STAFF RECOMMENDATION

1510 Ordway Place

April 15, 2015

Application: New construction-outbuilding; Setback determination

1510 ORDWAY PL

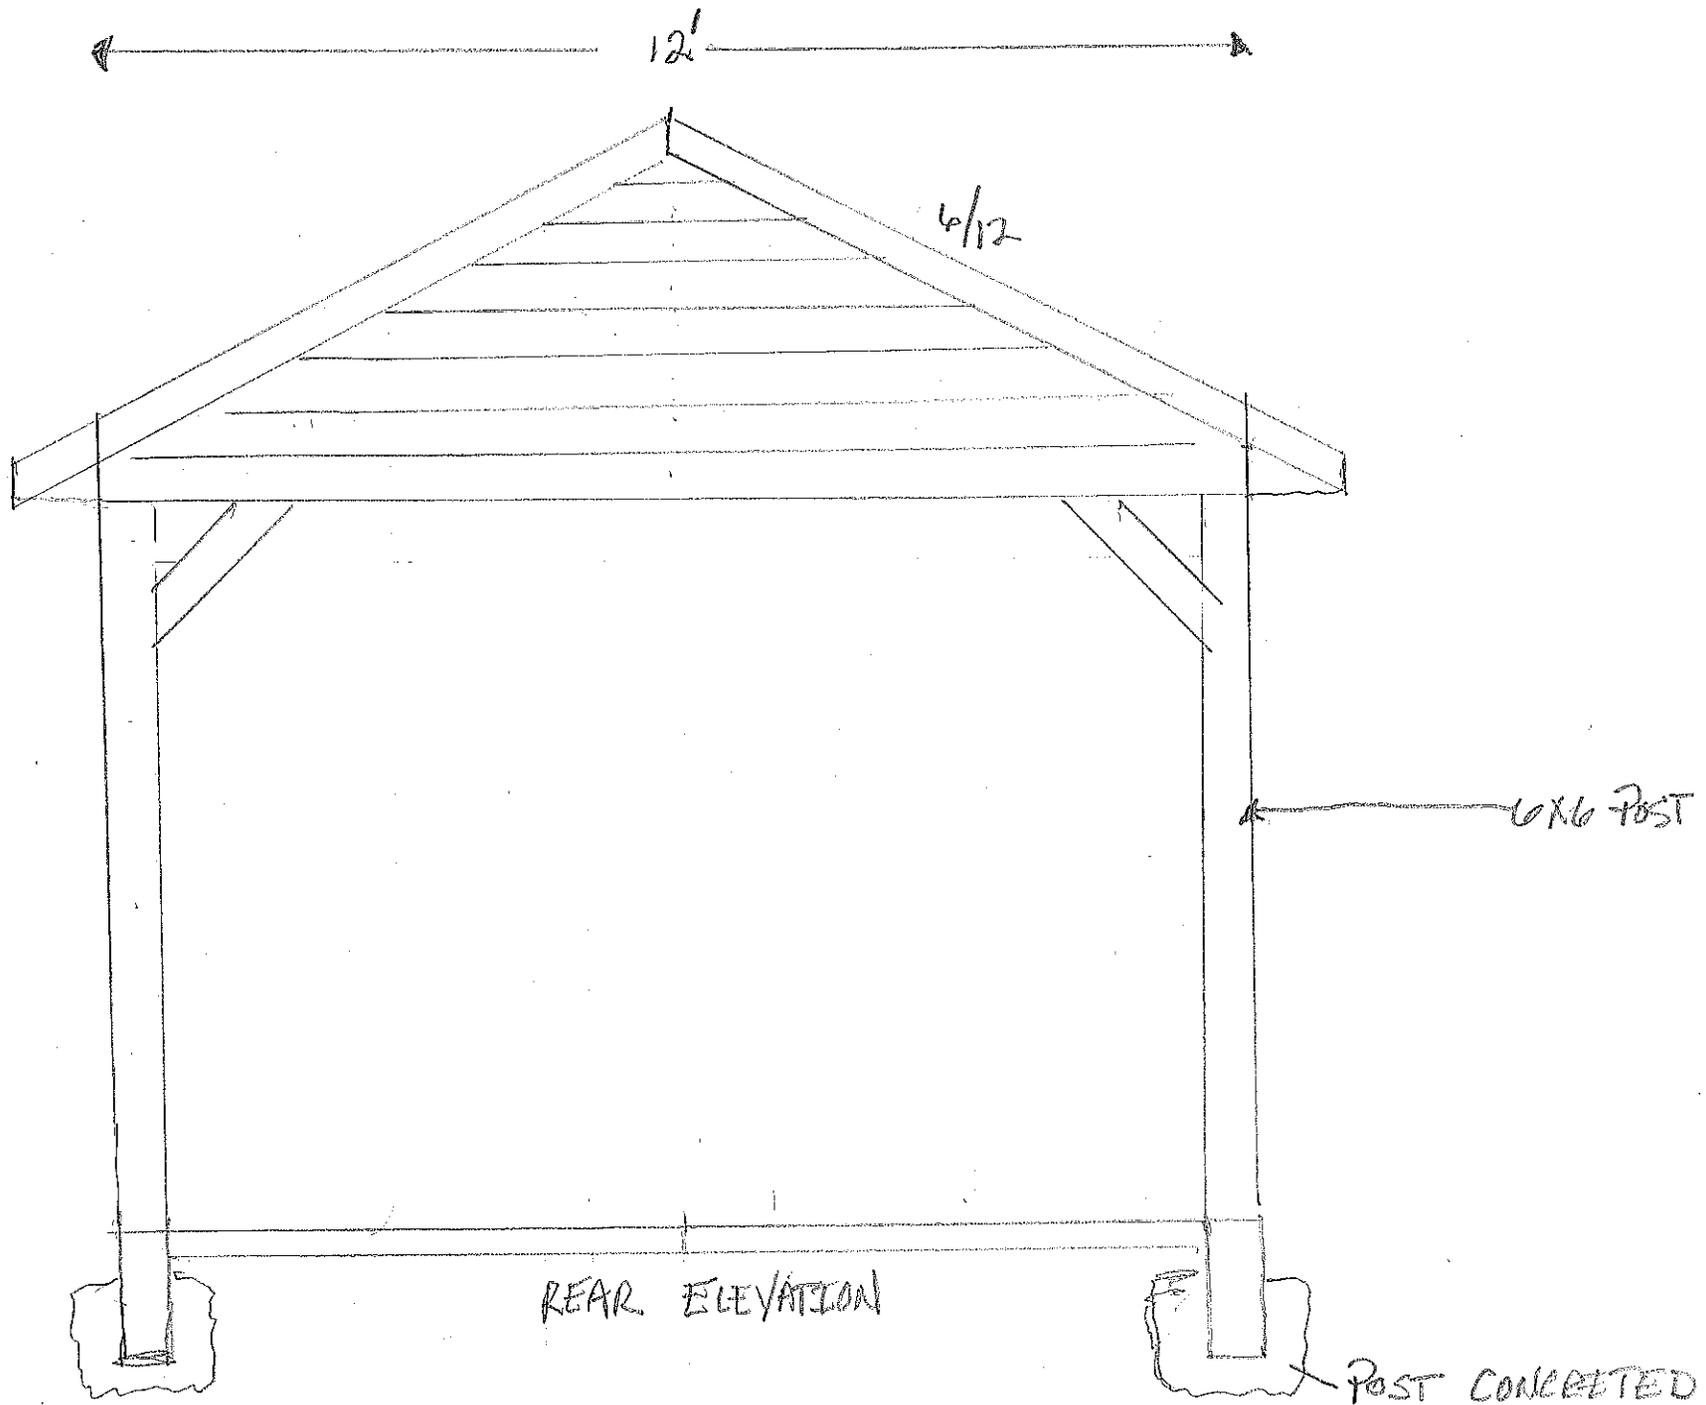
The building will be located six feet (6') from the alley at the rear of the lot. This is closer than the recommended ten feet (10') but it is consistent with the location of other outbuildings in the district that are as close or closer to the rear property line. Therefore, Staff finds the requested rear setback appropriate.

REAR ELEVATION

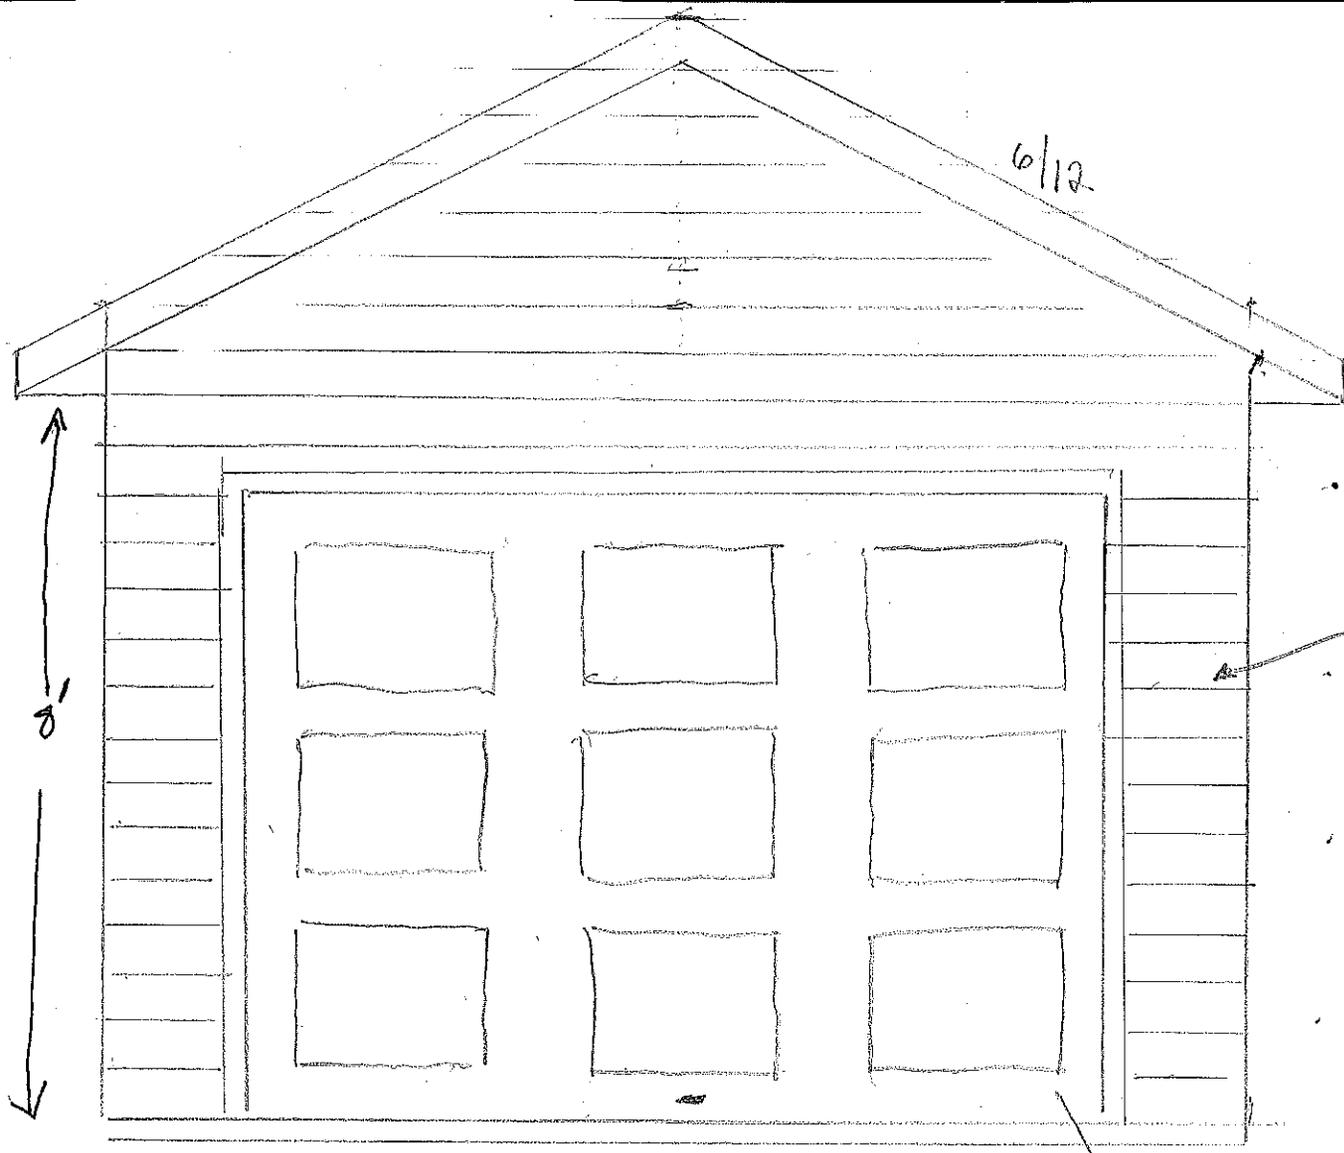
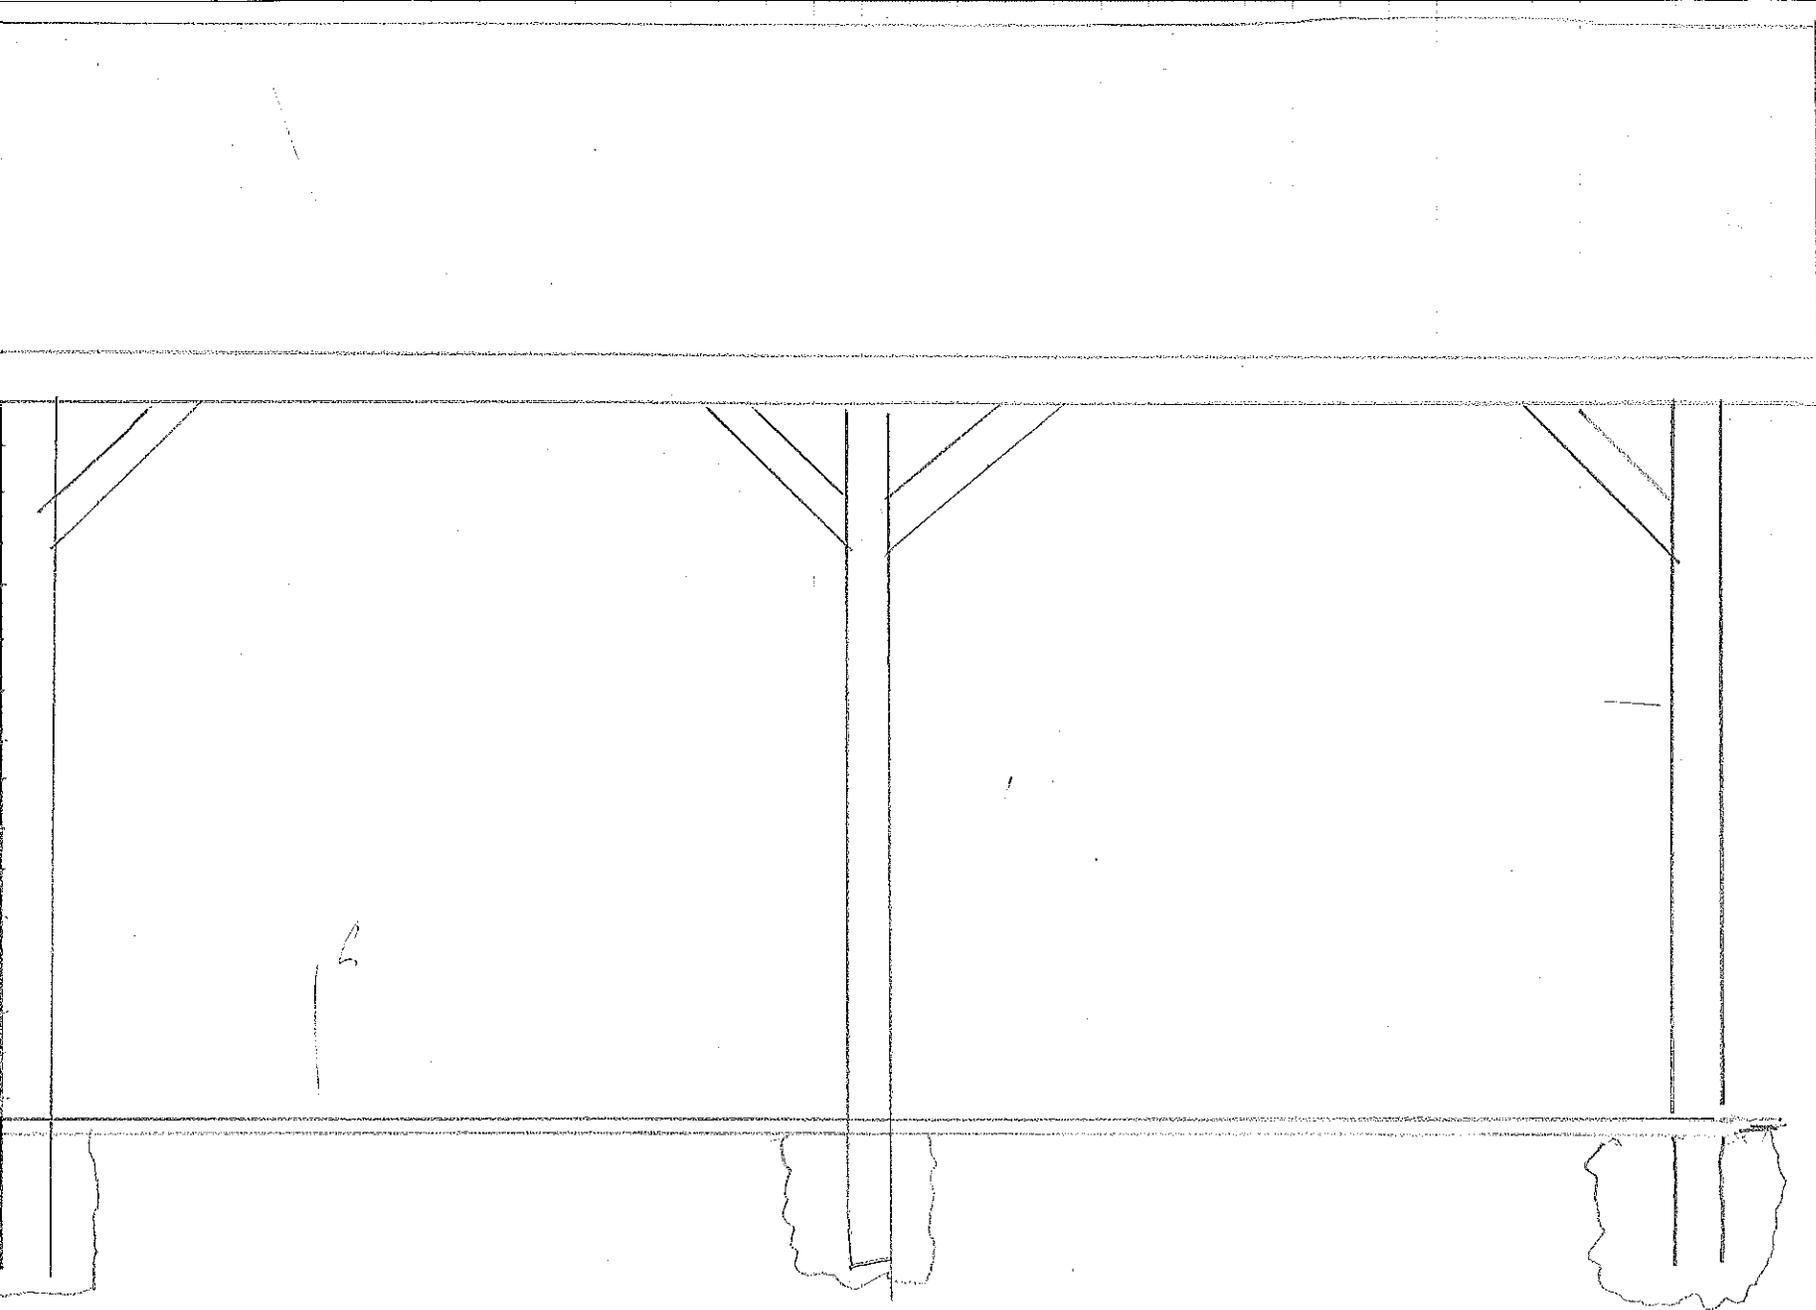
The proposed building is a one-story carport with a ridge height of approximately twelve feet (12') above grade. The building will be twelve feet (12') wide and eighteen feet (18') deep.

Character, Materials, Details: The outbuilding is simple and utilitarian in design. The cladding will be fiber cement siding with five inches (5") reveal. The roof shape and 4/12 pitch are similar to that of the house. Staff finds that the proposed outbuilding is compatible with the house and surrounding buildings, and meets the design guidelines for outbuildings. For the reduced rear setback, the applicant is requesting a setback determination from the Commission.
